DEPARTMENT OF THE NAVY
NAVAL FACILITIES ENGINEERING COMMAND
ATLANTIC
6506 HAMPTON BLVD
NORFOLK VA 23508-1278

- 1) Responses to Comments on Final Munitions and Explosives of Concern Master Work Plan, Former Vieques Naval Training Range (VNTR), Vieques, Puerto Rico.

Response to USEPA and PREQB comments dated December 21, 2006 – Review of the Final MEC Master Work Plan, Former Naval Training Range (VNTR), Vieques, Puerto Rico

Figure 2-1
Vieques MEC Project Team

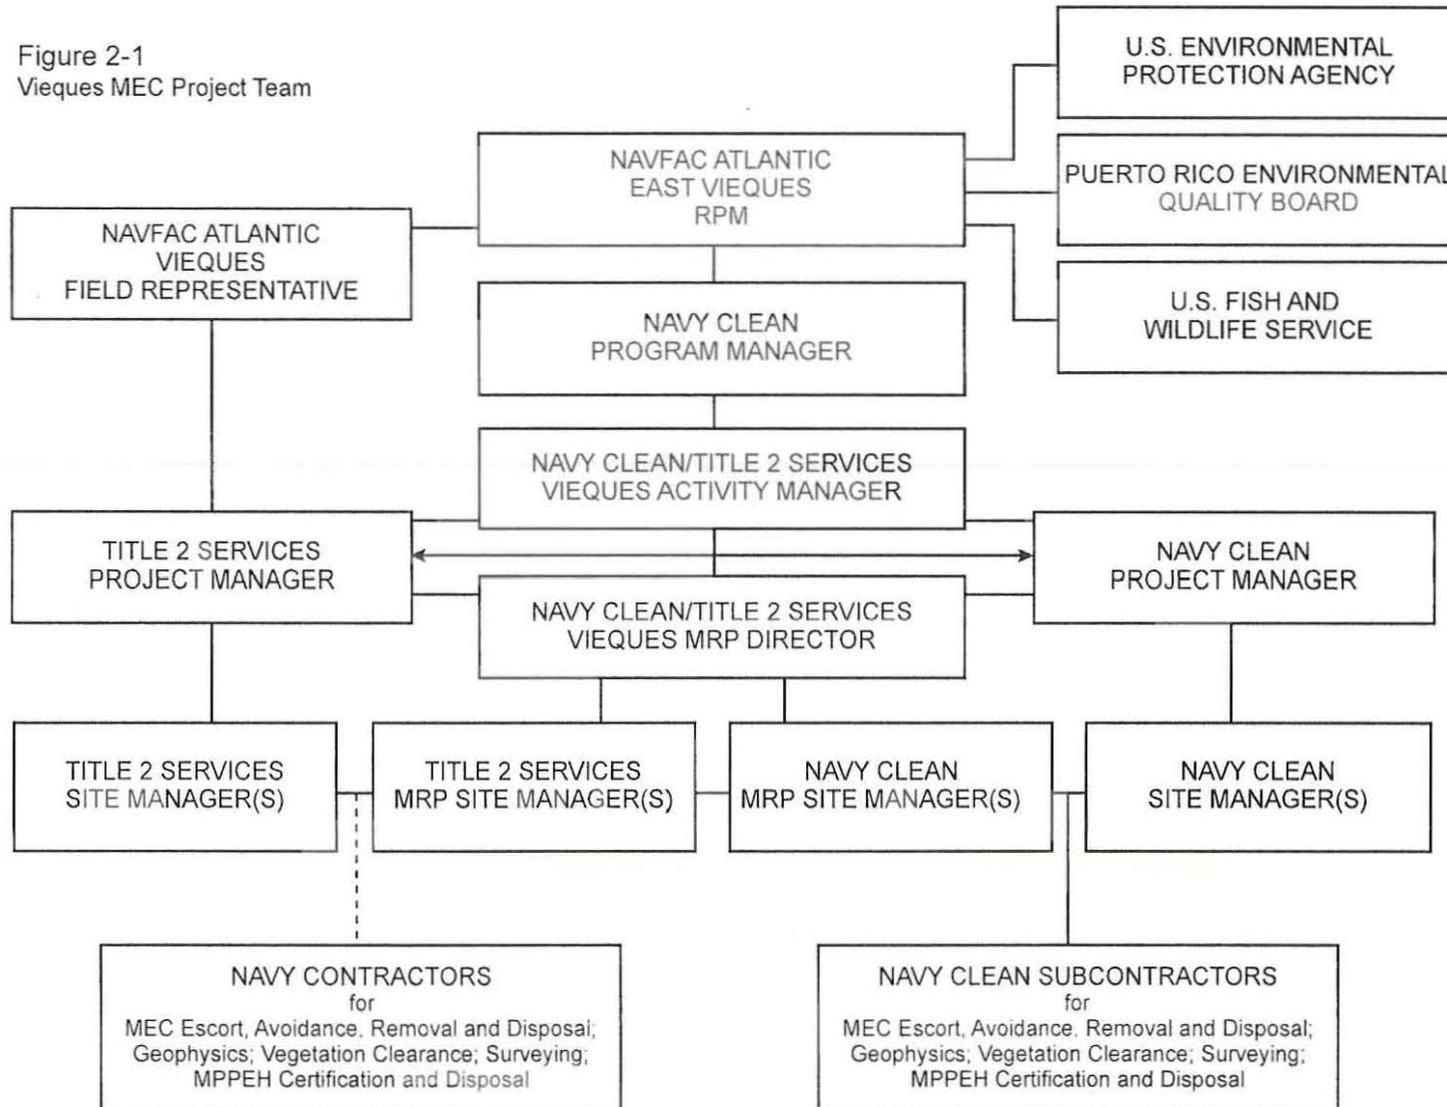
2. EQB has requested that Figure 2-1 be modified to include the agencies and regulators to show the lines of communication that will be used to provide information on the project. This was requested since EQB's earliest comments on the pre-draft MWP in December 2004 as documented by this comment:

"Page 2-5, Fig. 2-1:

1. Recommend adding dashed line boundaries or using shading to indicate which organizations the various personnel work for.
2. Add other members of the Project Team (EQB, USFWS, etc.) to the organization chart.
3. One block at the bottom references QA/QC. This is incorrect. These two functions are independent of each other and cannot reside with the same person or organizations."

Note that #2 above has never been addressed. It is likely that the project can benefit from improvements in communication and showing the relationship of the regulators and agencies to the project may help. EQB continues to request that this modification to Figure 2-1 of the MWP be implemented.

See attached change Page 2-9, which is Figure 2-1 showing communications with regulatory agencies and U.S. Fish and Wildlife directly with the NAVFAC RPM.
